**Well Name:** SAN JUAN

**Operator:** HILCORP ENERGY  
COMPANY

**Type of Submission:** Subsequent Report

**Type of Action:** Plug and Abandonment

### Current Schematic - Version 3

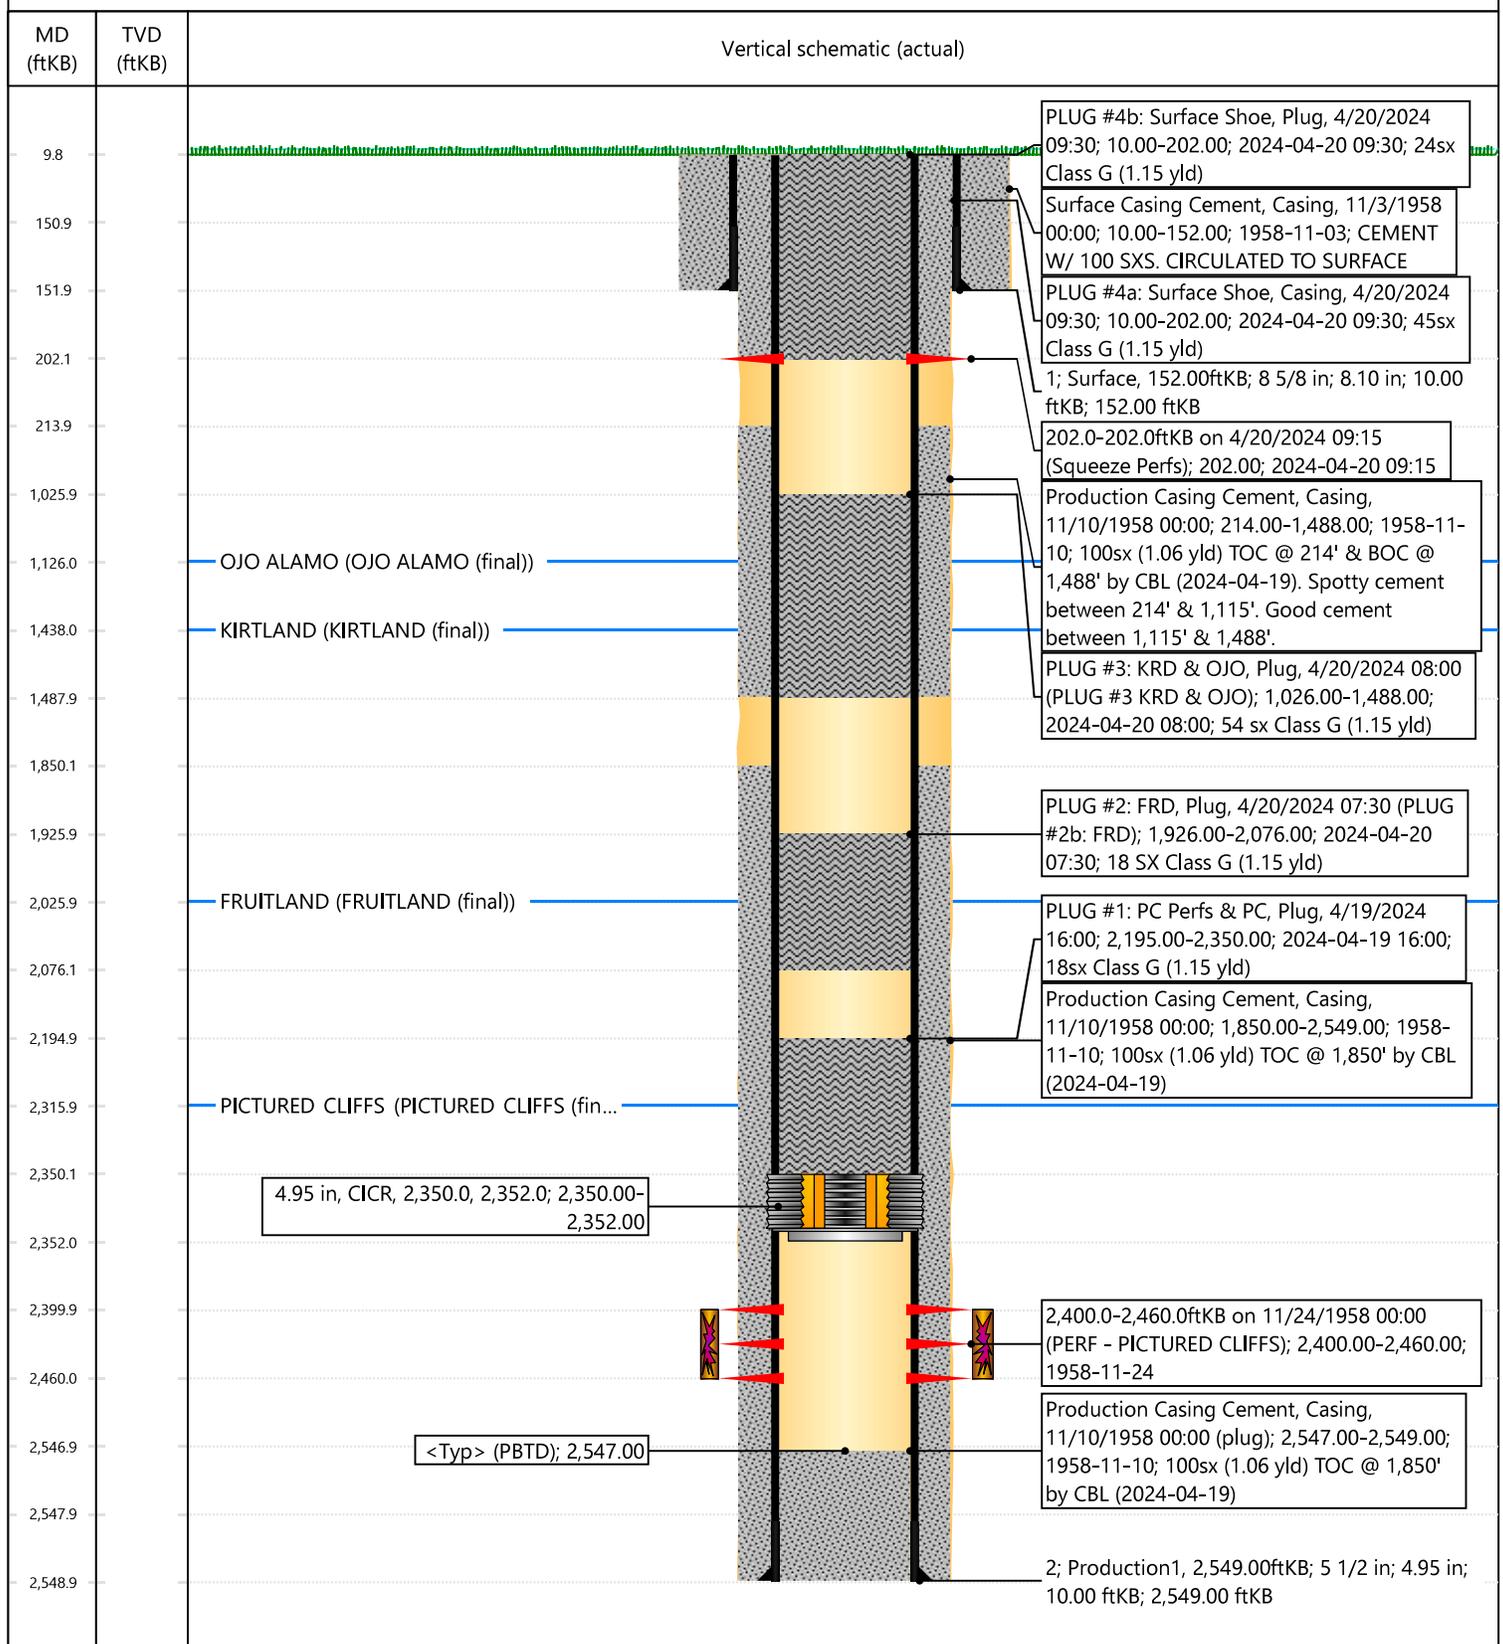
One adjustment Hilcorp would like to make from the approvals below is to split PLUG #3 (KRD & OJO) into two separate inside plugs. These will now be called PLUG #3 & PLUG #4 (outlined below). Do we have approval to split these plugs into two separate inside plugs?

- PLUG #3: 18sx Class G (1.15 yld) KRD Top @ 1,438':  
-Pump an 18 sack balanced cement plug inside the 5-1/2" casing (Est. TOC @ 1,338' & Est. BOC @ 1,488')
- PLUG #4: 18sx Class G (1.15 yld) OJO Top @ 1,126':  
-Pump an 18 sack balanced cement plug inside the 5-1/2" casing (Est. TOC @ 1,026' & Est. BOC @ 1,176')
- Additionally the surface casing shoe plug will now be called "PLUG #5" and will be pumped as outlined in the previous email (Perf @ 202', pump 58sx).

- PLUG #1: 18sx of Class G Cement (15.8 PPG, 1.15 yield); PC Perfs @ 2,400' | PC Top @ 2,316':
  - NO CHANGES
  - Pump an 18 sack balanced cement plug inside the 5-1/2" casing (est. TOC @ +/- 2,200' & est. BOC @ +/- 2,350'). \*Note cement plug lengths and volumes account for excess.
  - WOC & Tag
  - Once plug is pumped, pressure test 4.5" casing to 560 psi

- PLUG #2: 18sx of Class G Cement (15.8 PPG, 1.15 yield); FRD Top @ 2,026':
  - CBL shows good cement from 1,850' to 2,350' (bottom of log).
  - No need for an outside plug. Adjusting to inside plug only.

- PLUG #3: 54sx of Class G Cement (15.8 PPG, 1.15 yield); KRD Top @ 1,438' | OJO Top @ 1,126':
  - CBL shows cement from 214' to 1,442'.
  - No need for an outside plug. Adjusting to inside plug only.

- PLUG #4: 58sx of Class G Cement (15.8 PPG, 1.15 yield); Surf. Casing Shoe @ 152':
  - NO CHANGES
  - TIH & perforate squeeze holes @ +/- 202'. Establish circulation.

The BLM finds the procedure appropriate.

To confirm, the BLM finds the procedure appropriate.

NMOCD approves below with prior approval from the BLM
